Access Compliance Report

Public Rights-of-Way

(Curb Ramps)

Intersection ID: 51507	Main Street: ALDERSON_DR	Cross Street: NETHERTON_LN	Location: W
ADA ID: D996C1E350B8	Ramp Type: PerpDiag	Initial Pass/Fail: Fail	Overall Compliance: No
Severity Score: 33.75			
Codes/Mitigation Info/Possible Solution		Field Measurements/Component Compliance

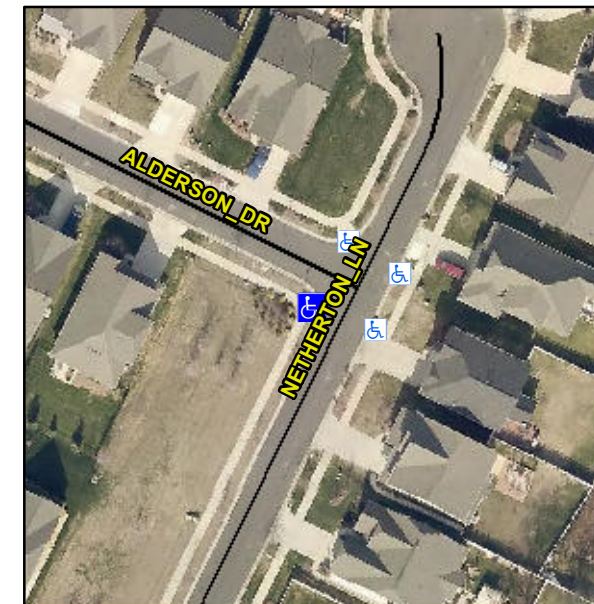
Not Found, R304.5.1, R304.5.3

Compliance	Description	Data	Compliance	Description	Data
N/A	Ramp Length (in)	72.0	Yes	Ramp Slope (%)	5.4
No	Ramp Width (in)	47.5	No	Ramp XSlope (%)	8.6
N/A	Flare Type LT	N/A	N/A	Flare Type RT	N/A
N/A	Flare Slope LT (%)	N/A	N/A	Flare Slope RT (%)	N/A
N/A	Flare Traversable LT?	N/A	N/A	Flare Traversable RT?	N/A
N/A	Landing Length (in)	N/A	N/A	DWS Provided?	N/A
N/A	Landing Width (in)	N/A	N/A	DWS Contrast?	N/A
N/A	Landing Slope (%)	N/A	N/A	DWS Length (in)	N/A
N/A	Landing X Slope (%)	N/A	N/A	DWS Full Width?	N/A
N/A	Landing Curb? (Y/N)	N/A	N/A	DWS Offset (in)	N/A
N/A	Shared Landing?	N/A			
N/A	Gutter Ponding?	N/A	N/A	Gutter Slope (%)	N/A
N/A	Gutter Lip Ht (in)	N/A	N/A	Gutter X Slope (%)	N/A
N/A	Painted X Walk1?	No	N/A	Painted X Walk2?	No
	X Walk 1 Direction	To SE		X Walk 2 Direction	To NE
N/A	X Walk 1 Width (in)	N/A	N/A	X Walk 2 Width (in)	N/A
	X Walk 1 Slope (%)	3.2		X Walk 2 Slope (%)	1.5
	X Walk 1 X Slope (%)	4.7		X Walk 2 X Slope (%)	4.4

Remove & Replace Curb Ramp With Two New Directional Ramps or Equivalent.
